**TRANSMITTAL OF RESPONSES TO OHIO ENVIRONMENTAL PROTECTION
AGENCY COMMENTS AND CHANGE PAGES TO THE FINAL CERTIFICATION
DESIGN LETTER AND CERTIFICATION PROJECT SPECIFIC PLAN FOR AREA 6
GENERAL AREA WEST**

**RESPONSES TO
OHIO ENVIRONMENTAL PROTECTION AGENCY
COMMENTS ON THE
FINAL CERTIFICATION DESIGN LETTER AND
CERTIFICATION PROJECT SPECIFIC PLAN
FOR AREA 6 GENERAL AREA WEST**

**CERTIFICATION DESIGN LETTER AND
CERTIFICATION PROJECT SPECIFIC PLAN
FOR AREA 6 GENERAL AREA WEST**

**20600-PSP-0020
REVISION 0
PCN 1**

FIGURE 4-5. SUB CU AND SAMPLE LOCATION MAP FOR AREAS 7A & 7C

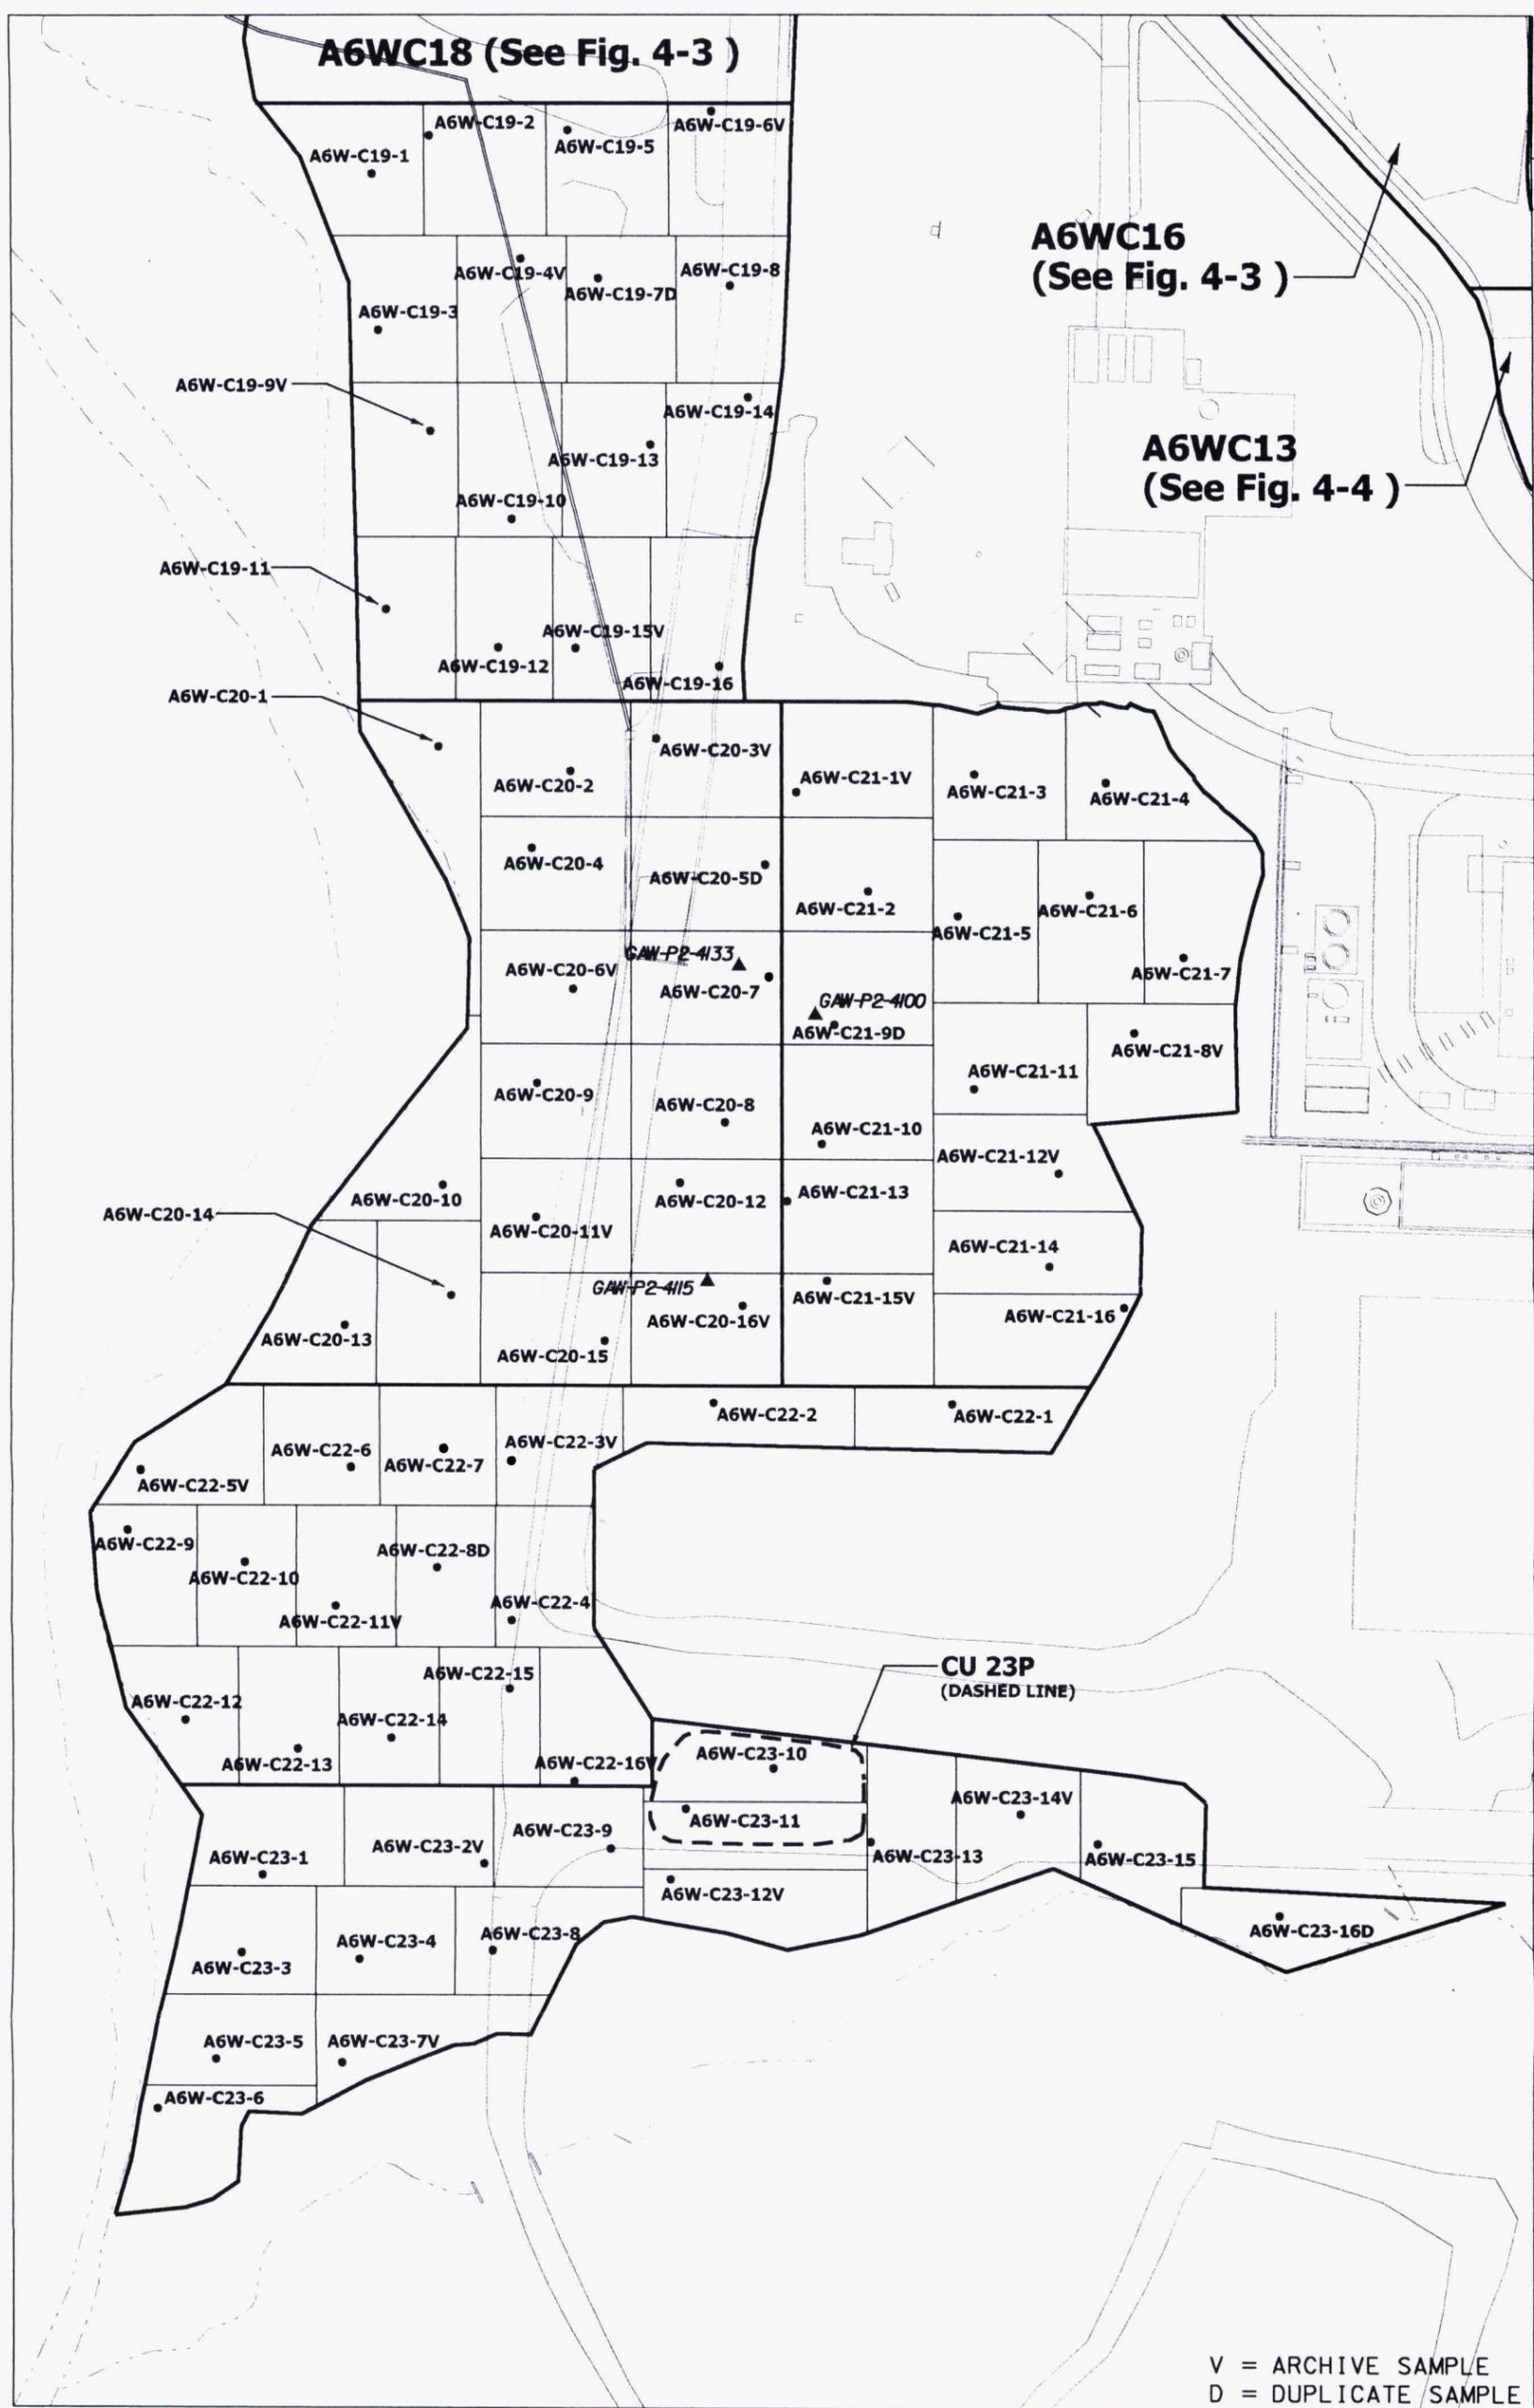
<u>Revision</u>	<u>Date</u>	<u>Description of Revision</u>
Revision 0	10-11-06	Initial controlled issuance.
PCN 1	10-18-06	Revisions were made to Sections 2.2.2, 2.4.2, 2.6, 3.2.4, 3.2.5, 3.2.6, 4.1.1, 4.1.2, Table 3-3, and Figure 4-5 to incorporate additional OEPA comment responses.
